TRANS/WP.29/GRSG/2002/6  
29 July 2002

World Forum for the Harmonization of Vehicle Regulations (WP.29)

PROPOSAL FOR DRAFT AMENDMENTS TO REGULATION No. 52

(Small capacity passenger vehicles, M2 and M3 category)

"Figure 7

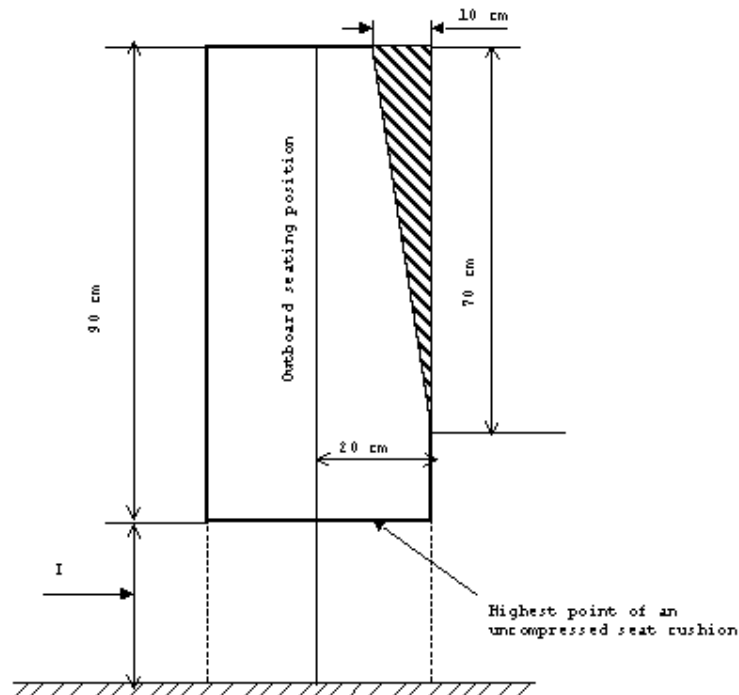
"5.7.8.1.3.2. Intrusion of a structural member provided that the intrusion is included within a triangle whose peak is situated ~~65 cm~~ **70 cm from the top** and whose base is 10 cm in width and situated in the upper part of the space in question, adjacent to the side wall of the vehicle (see annex 3, figure 7)"

Annex 3, Figure 7, amend to read:

The alteration corrects figure 7. The requirements of figure 14 for the "I" value are also transferred to figure 7 to make clear that the general prescriptions of paragraph 5.7.8.3. also apply to paragraph 5.7.8.1.3.2.

As there are different values for "I" the former method to define the starting point for the triangle representing the permitted intrusion needs to be revised, in order to establish equal conditions for all of the different values. Measuring from the top of the minimum height above the seat and leaving the geometry of the triangle unchanged achieves this.

I (cm) min.
Class I	40-50
Class II	(for classes I and II min 35 cm at wheel arches and engine compartment)
Class III
